Technical release

The release covers the necessary changes to the Valx axle and the hubodometer hub cap in the context of retrofitting a trailer fitted with Valx axles to accommodate the PSI System.

| Version: | VF-TA-0003-C |

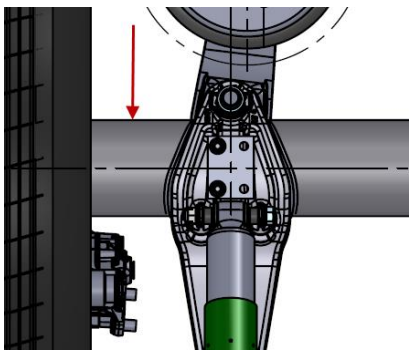
1-Drill a hole from 8,6 mm in the axle beam to make the air pressure connection possible.

After drilling this hole a 1/8"BSPT (GAS) thread has to be cut in this hole.

The drilled hole has to be on the center line from the axle beam, horizontal and between the air suspension and the brake. See the red arrow in the picture below.
